501 Charmany Drive
Contract 8166
MUNIS 11847
Developer: University Research Park, Incorporated

ADDENDUM NO. 1:

Re: City Directed Changes to Completed Work
New Intersection at South Whitney Way and Endeavor
Innovation One / Exact Sciences & University Research Park

Subject: Whitney Way Turn Lane Redesign &
Construction

TYPICAL FINISHED SECTION
WHITNEY WAY LEFT TURN LANE
STA 2+81 TO STA 6+50

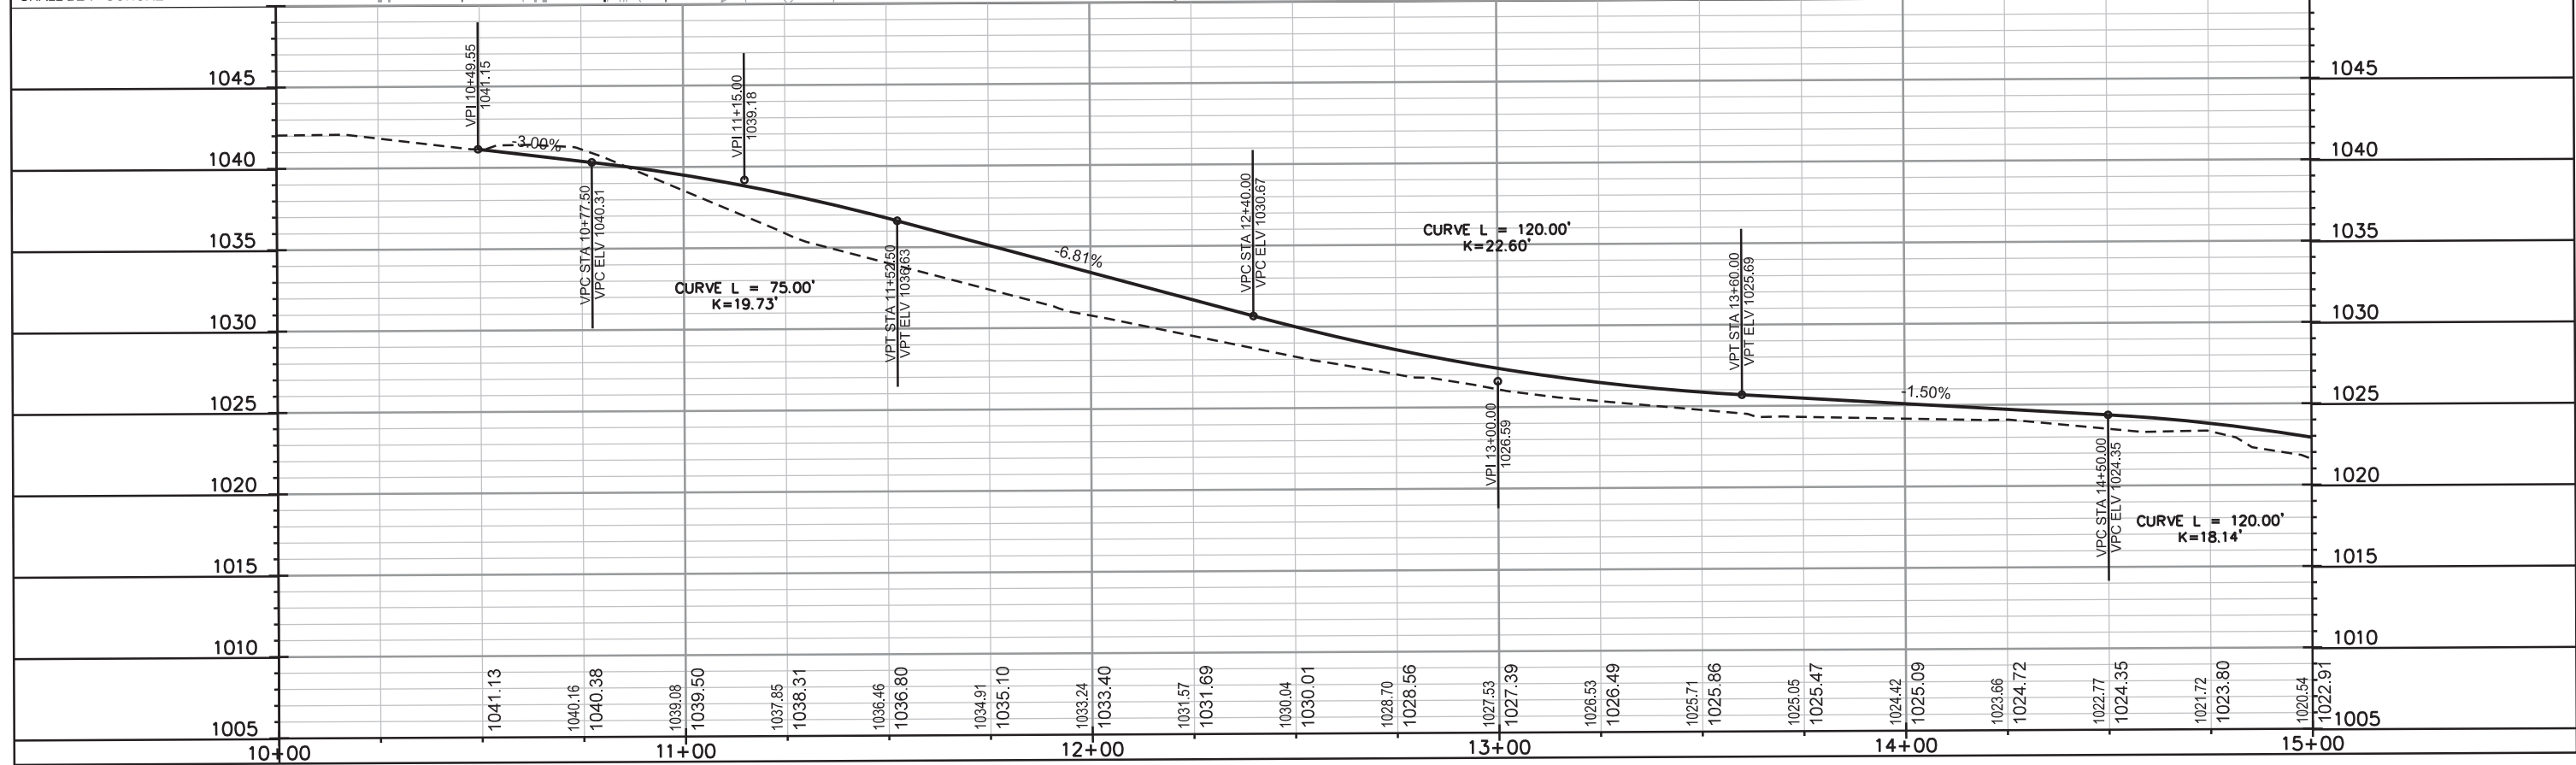
- Based on standard 6-bag 4,000 psi concrete mix design during normal business hours Monday - Friday.
- Color hardener is not included.
- No monolithic pouring of curb sections as shown on D-2.

REVISION 6/20/19 AJZ
- Whitney Way typical

POUR CURB & GUTTER AND
TERRACE BETWEEN
AS MONOLITHIC

- On June 26, 2019 the City approved via email to Derek Burdick of Findorff that the South Whitney Way north bound left turn lane median C&G does not have to be a single pour of concrete.

UNIVERSITY RESEARCH PARK/ INNOVATION ONE	SHEET NO. U-4
STORM SEWER SCHEDULE	
PROJ #11847	CITY OF MADISON

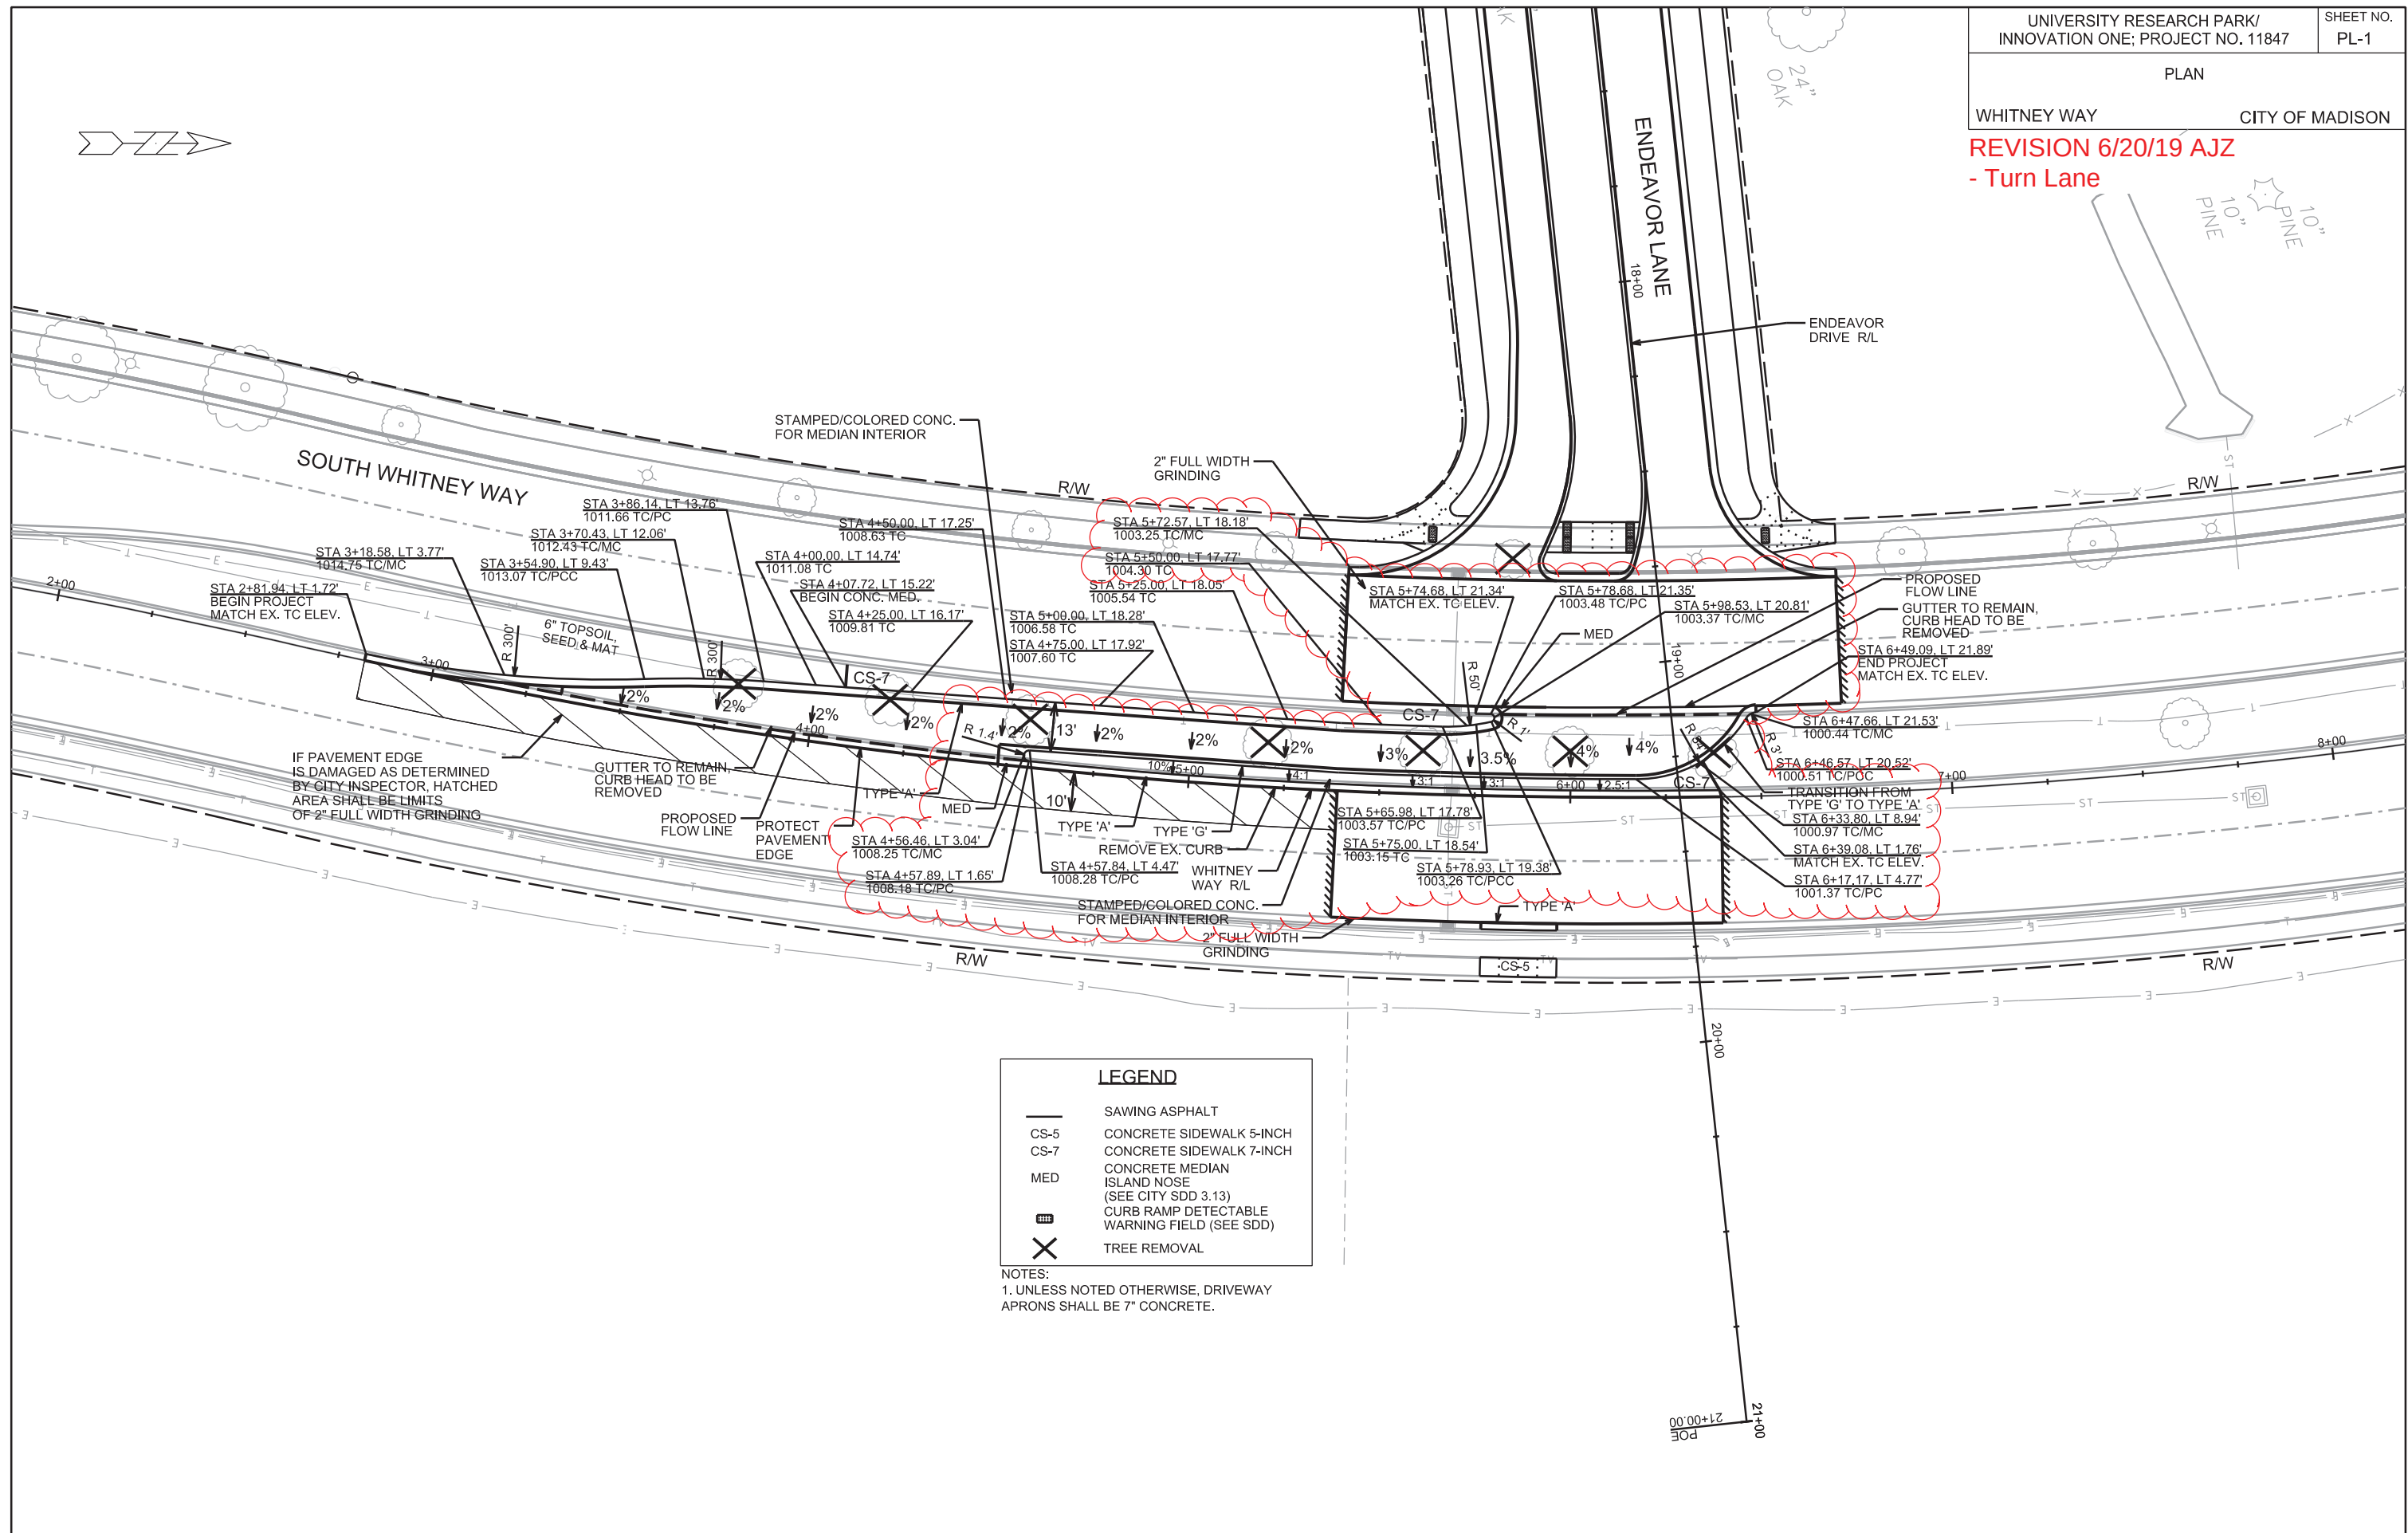
* REV 5/14/2019 DAO
** REV 6/17/2019 DAO

ADJ-1	IN 3357-011	5+68.98	LT-1.26	1002.45	1002.44	-0.01	
ADJ-2	IN 3357-010	5+68.88	LT-21.55	1003.69	1003.03	-0.66	
** ADJ-3	IN 3357-009	5+69.00	LT-58.02	1003.27	1003.30	0.03	(4) TO BE REMOVED (RS-1)
** RS-1	IN 3357-009	5+69.00	LT-58.02				PLUG PIPE

- R.G. Huston Company Inc. listed an inlet removal, 48" precast manhole, a pipe plug, and pipe collars that are not within the South Whitney Way left turn lane. The City will not pay for those items. The City will pay for the earthwork associated with the South Whitney Way left turn lane C&G removal and replacement.
